TECHNICAL SERVICE BULLETIN

10059

MODEL(S): 200 GTL DX with factory talk-back

DESCRIPTION: How to adjust the talk-back volume.

R109

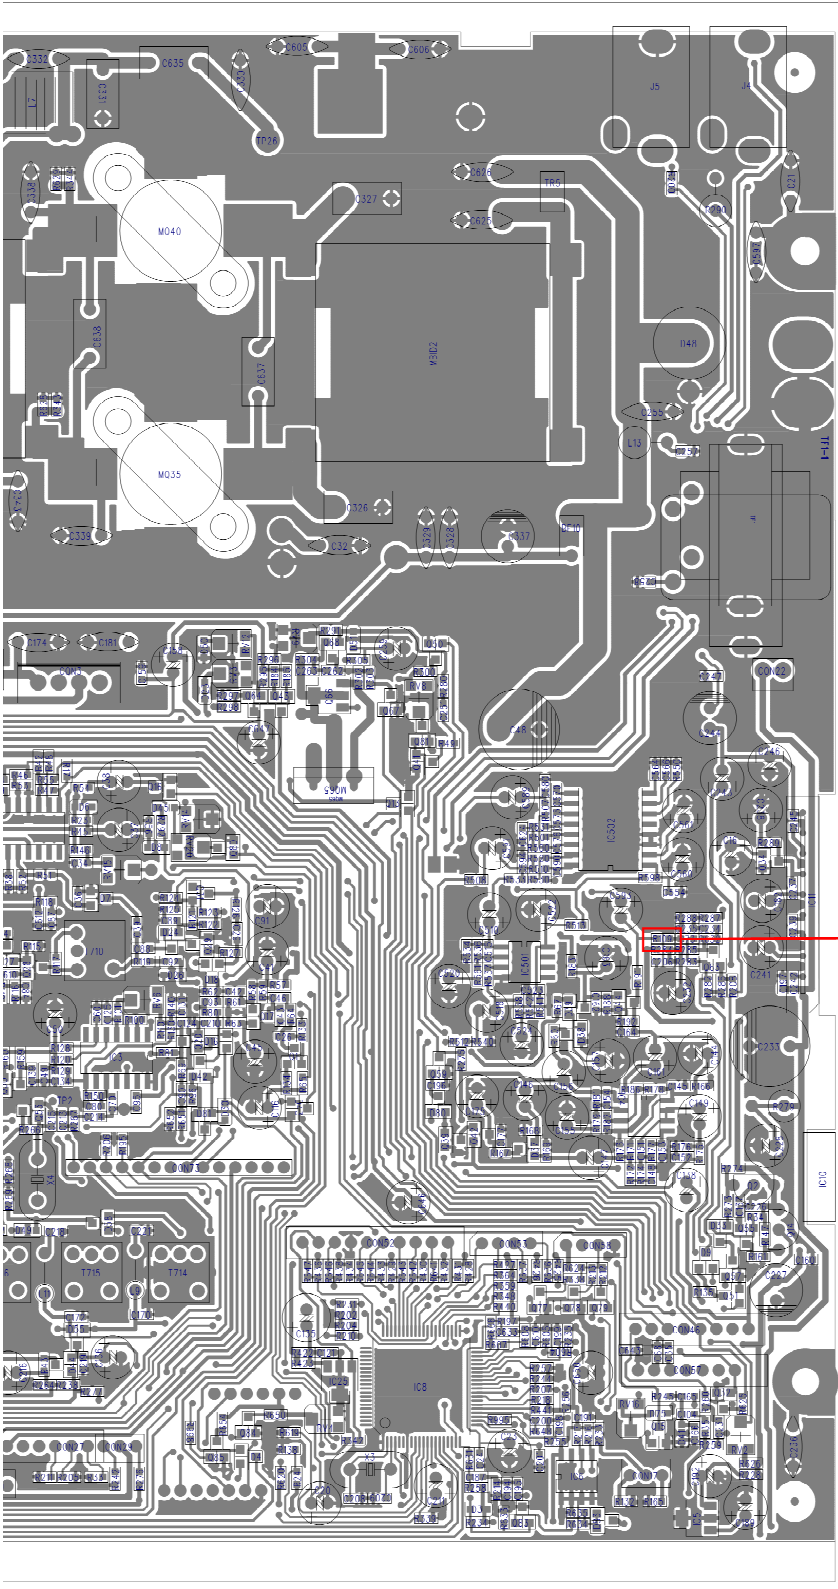
ACTION: To change the talk-back volume, adjust R109. The location of R109 is shown on pages 2-3.

To increase the talk-back volume, decrease R109. The factory value is 36K Ω .

NOTES: If the talk-back volume is turned too high, acoustic feedback can occur which will cause a squealing noise. The solution is to turn down the talk-back volume.
